**To: All Vendors Bidding on The College of New Jersey  
Field Hockey/Lacrosse E-Layer Replacement Project**

**ADDENDUM NO. 1**

**REFERENCE:** The College of New Jersey  
Field Hockey/Lacrosse E-Layer Replacement Project  
Bid No. AB200033

## **E-LAYER TO EXISTING CURB** **CONNECTION DETAIL** **N.T.S.**

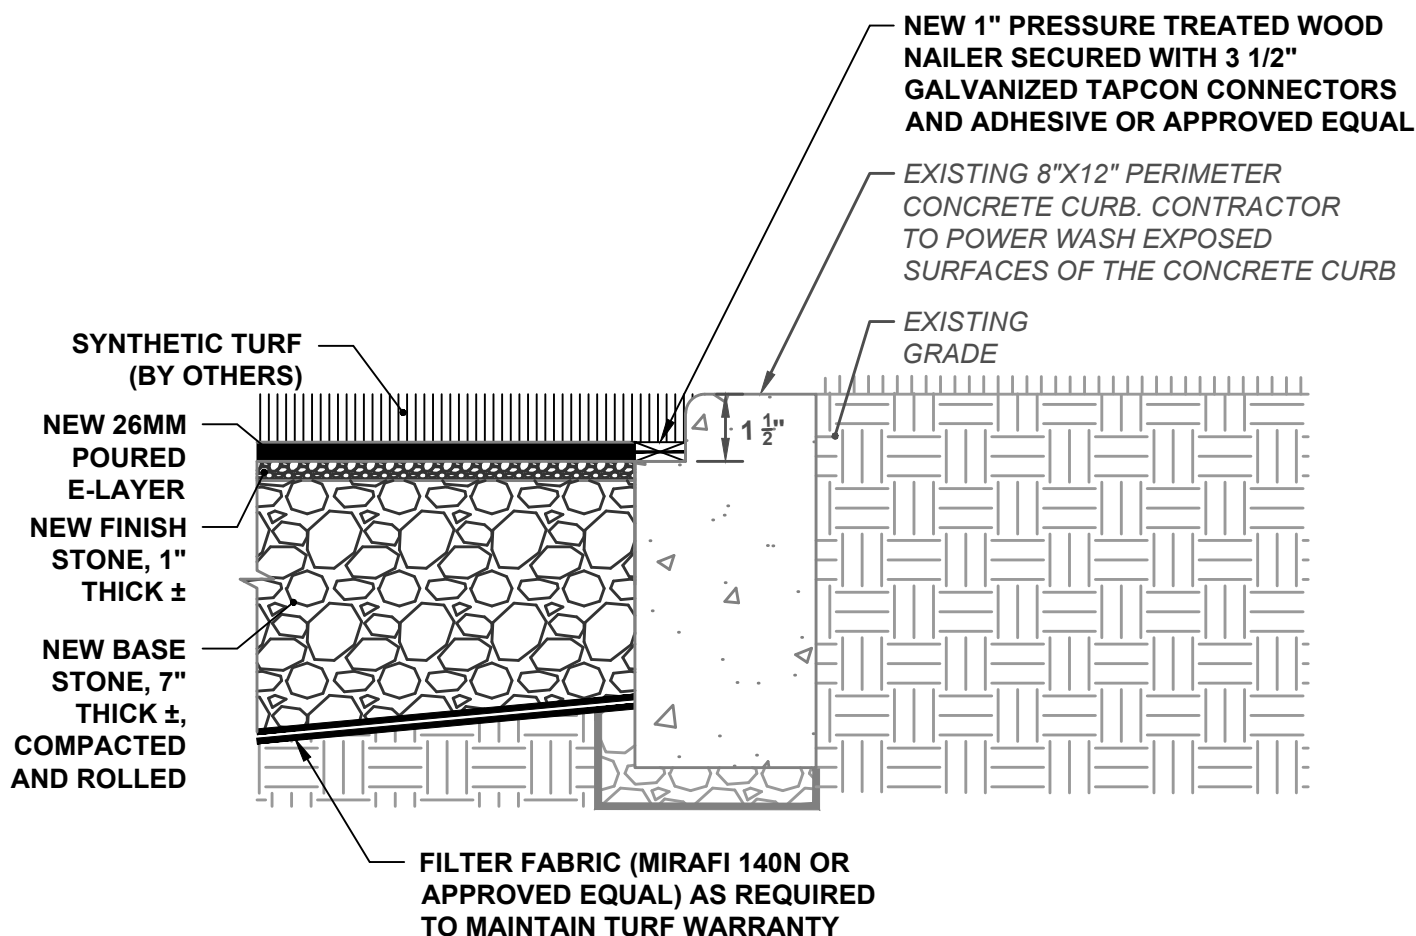
2. The project will include the installation of a wood nailer board in accordance with the detail attached.
3. The stabilized construction entrance as shown on Sheet 4 of 5 of the plans is deleted. Construction access will be through the existing construction access. Steel plates or other method acceptable to the College shall be used to protect the existing sidewalk and curb at this location. Any damage to existing surfaces to remain shall be repaired by the Contractor at no additional cost to the College. Please see the revised construction entrance detail attached.
4. The turf system being supplied under a separate contract will be Astro Turf Poligrass Platinum.

9. Please provide an edge detail (nailer board?) for the synthetic turf and is it part of this bid?

14. Drawings identify "curb by others," who are others? The curb and the nailer board are not included in the AstroTurf scope of work.

**Response:** Please see Clarification #2 above and attached detail.

**Response:** The curbing has been inspected and found to be in good condition and will not need replacement. The nailer installation will be included as part of this project. Please refer to the clarification section of this addendum above, question #9 above and the attached detail.
